AGENDA
BOARD OF EDUCATION – SPECIAL MEETING
Instructional Planning Center/Huron Arena
August 26, 2015
5:30 p.m.

CHANGE ORDER NO. G-4

Date: 08/04/15
 Project: Washington Elementary School Addition & Renovation/ 1277A
 Subject: Architect's Proposal/Change Order Log
 To: Welfl Construction Company

Huron School District
Washington 4 - 5 Center Addition & Renovation

VEST. 182 - MODIFIED DOORS FLOOR PLAN

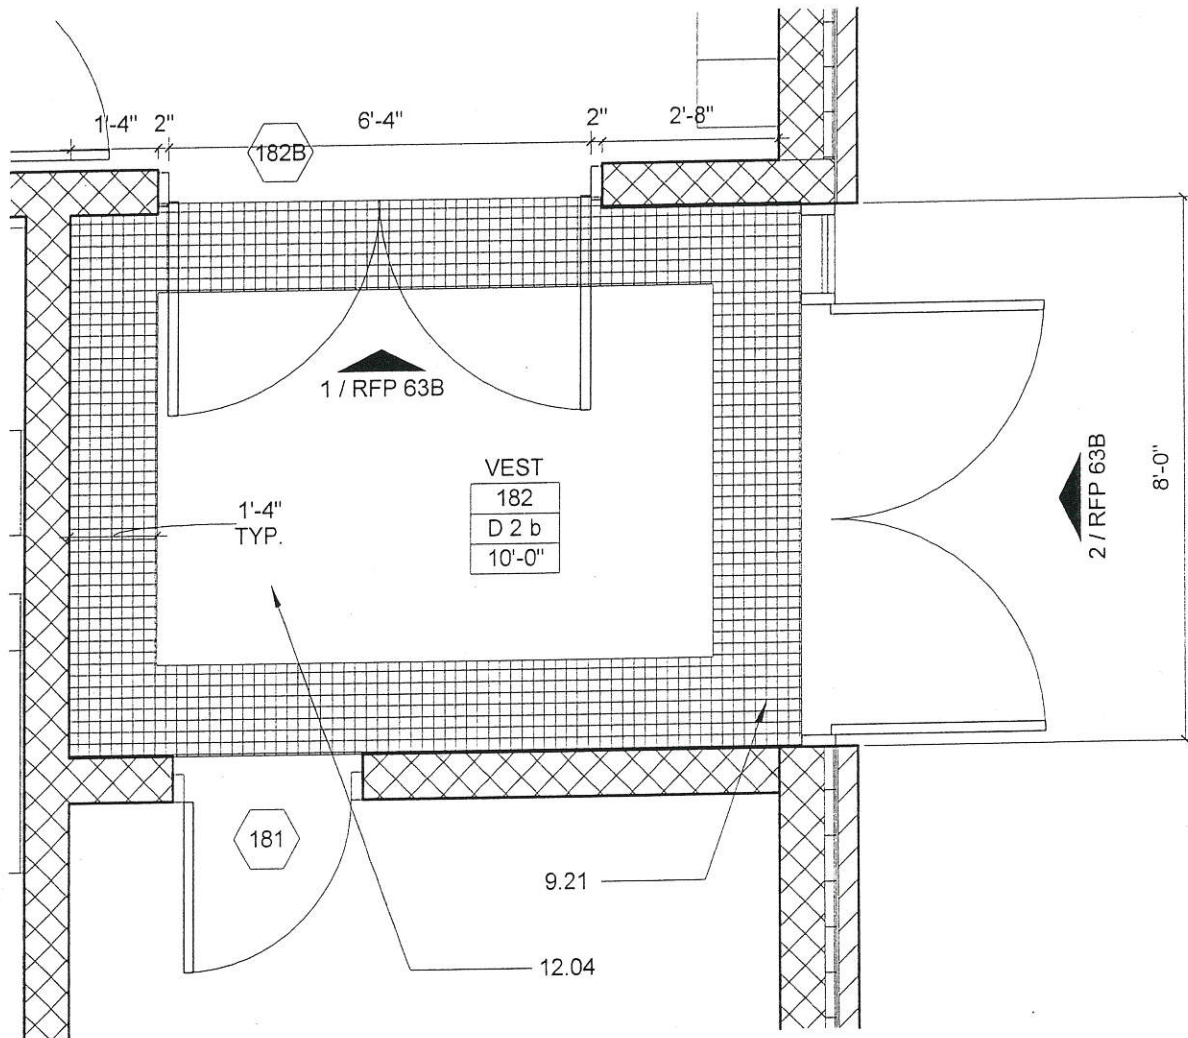
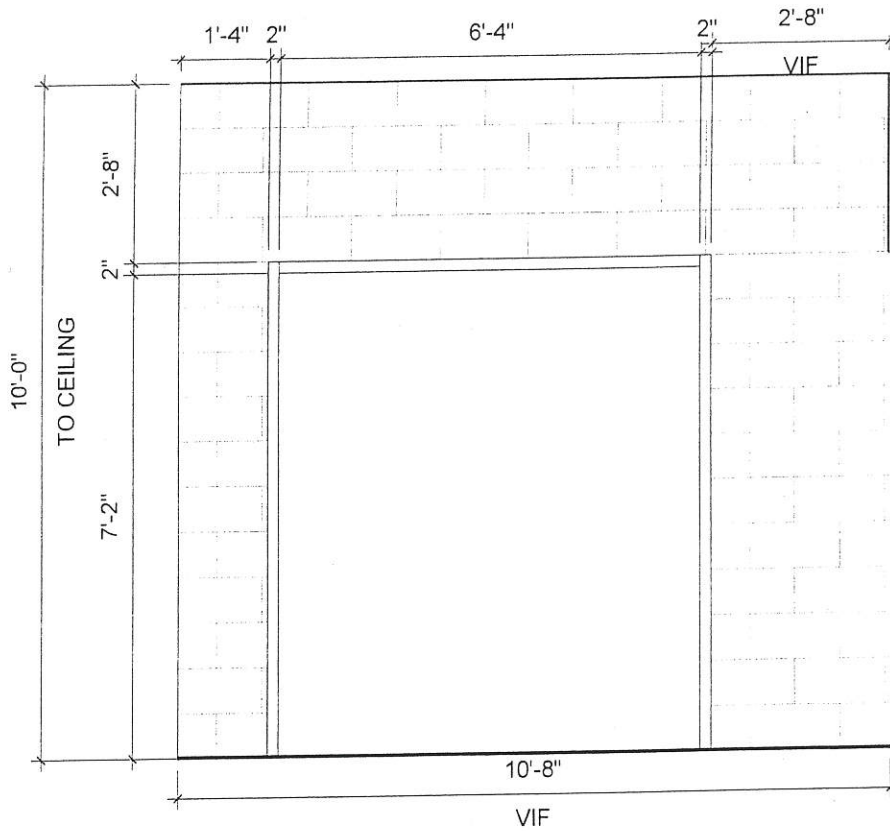
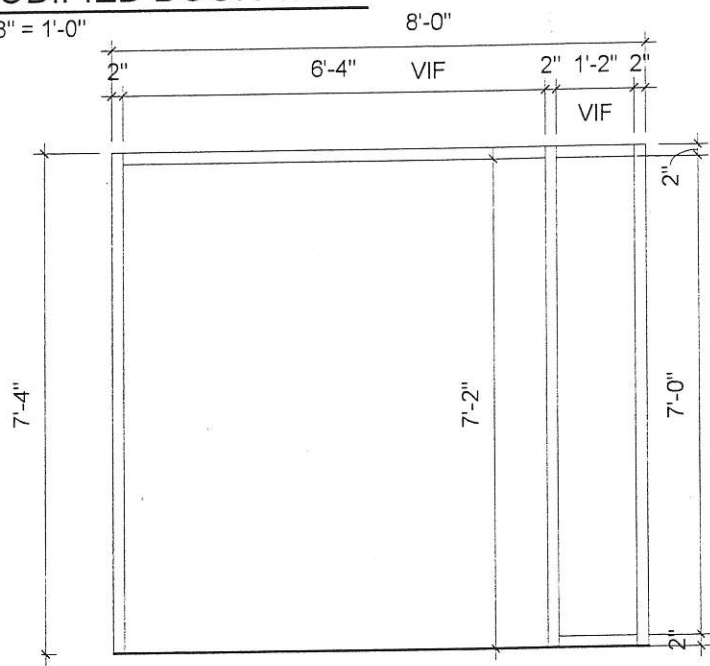
1. Add additional CMU to the wall to the west of Vestibule 182 and modify current frame type 11 – remove sidelights and transom. Use current scheduled doors and hardware.
2. Modify current frame type 10 – remove east sidelight and provide a larger sidelight on the west side. Use current scheduled doors and hardware.
3. See attached drawings.

Add additional CMU to the wall to the West of Vestibule 182 and modify current frame type 11 - remove sidelights and transom. Use current scheduled doors and hardware.

Modify current frame type 10 - remove East sidelight and provide a larger sidelight on the West side. Use current scheduled doors and hardware.

The total amount to provide this work is \$-559.00

① **FIRST FLOOR - AREA C OPTION**
 1/8" = 1'-0"

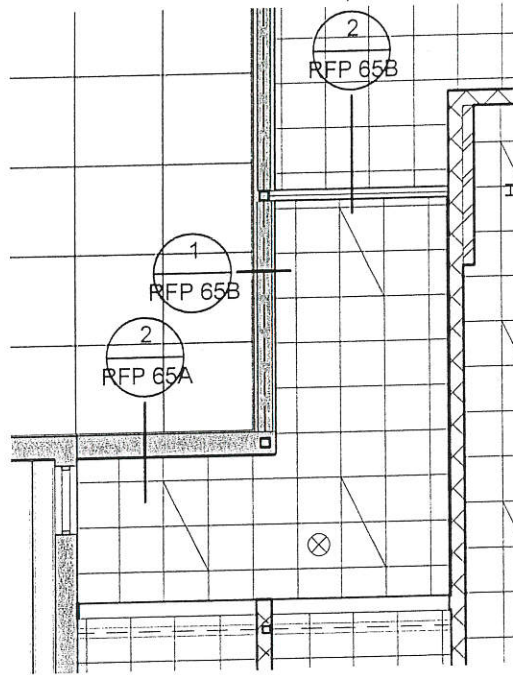
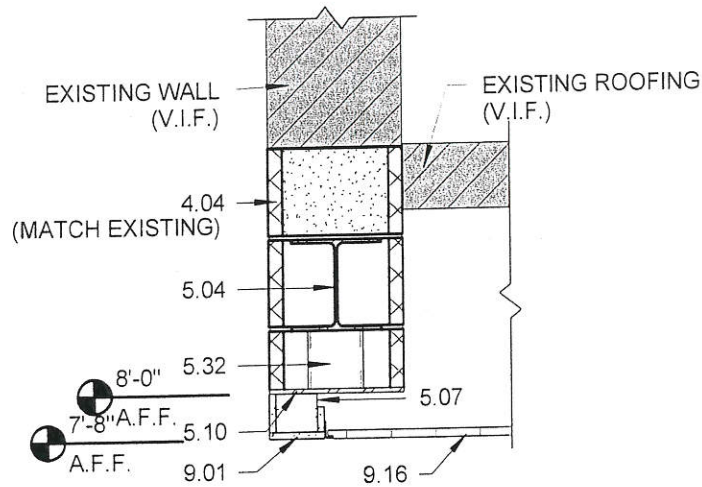
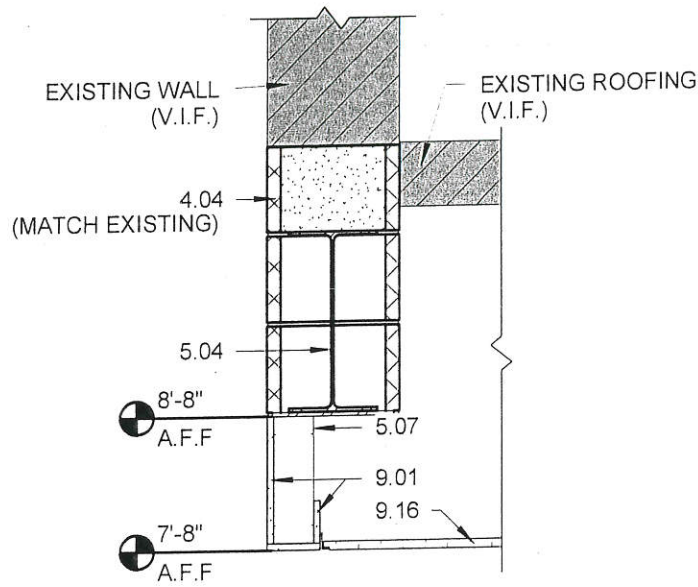
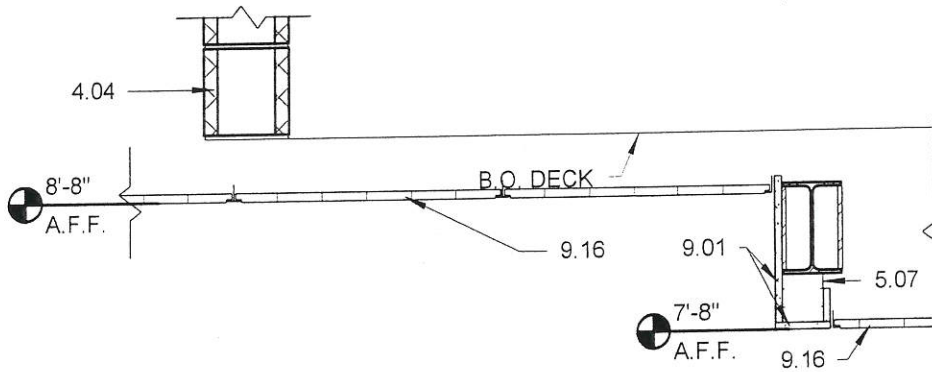
1. Lower the ceiling between Doors 160B/C and Grid Line D in Corridor 192 to 7'-8" in lieu of 8'-0".
2. Rotate lighting 90 degrees and place between new joists.
3. Replace Detail 1/A3.6 on page A3.4 with ACP that continues from Commons 160A to Grid Line D at 8'-8".
4. Install bulkheads around lowered ceiling. Columns shall be built into new bulkheads, not the ACP ceiling.
5. See attached drawings.

The total amount to provide this work is \$1,365.00

CEILING CLOUD MODIFICATION

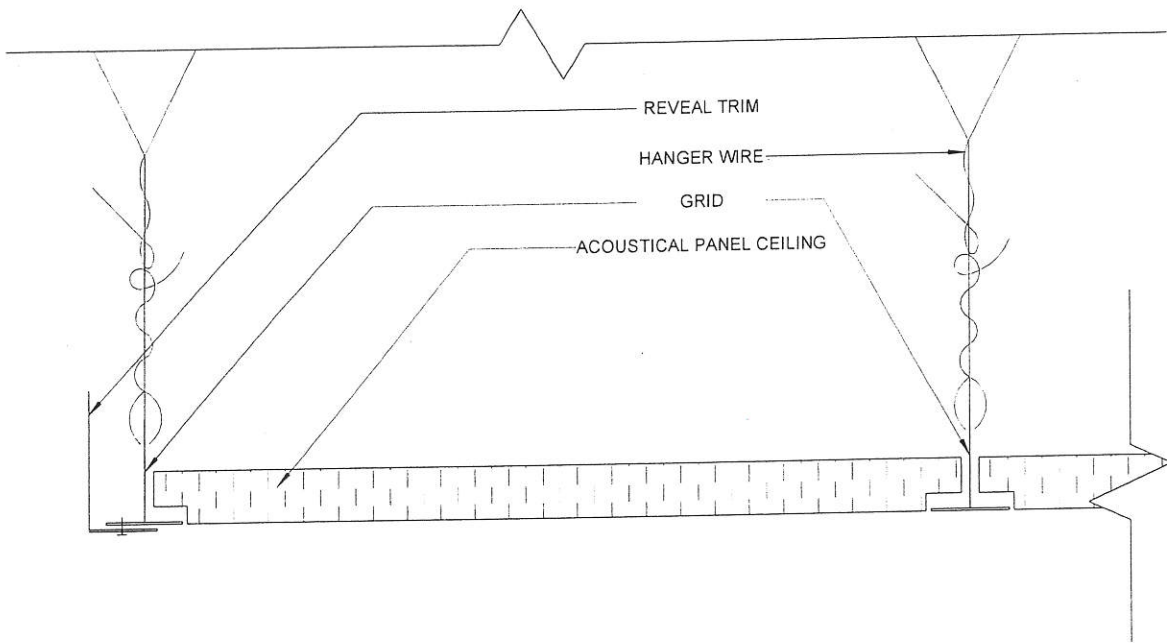
1. Revise cloud detail 2/A3.6.
2. See attached drawing.

Revise cloud detail 2/A3.6

The total amount to provide this work is \$-420.00

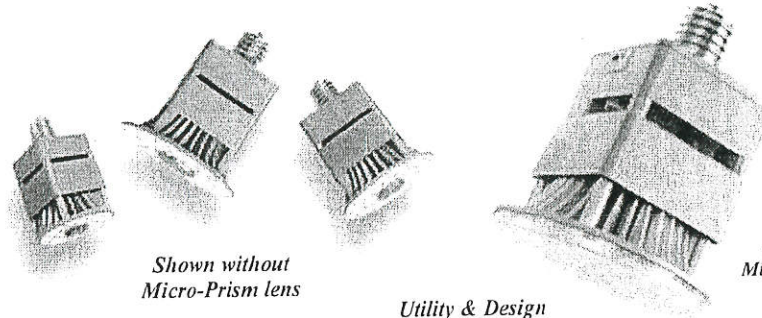
1. Provide an itemized proposal for new LED light fixtures in existing Commons;
2. Reference electrical plan sheet E3.5, room 160: Retrofit 8 existing type "XG" and 1 existing type "XG1" luminaires with GPE 600750 LED lamp.
3. See attached.

The total amount to provide this work is \$4,690.00
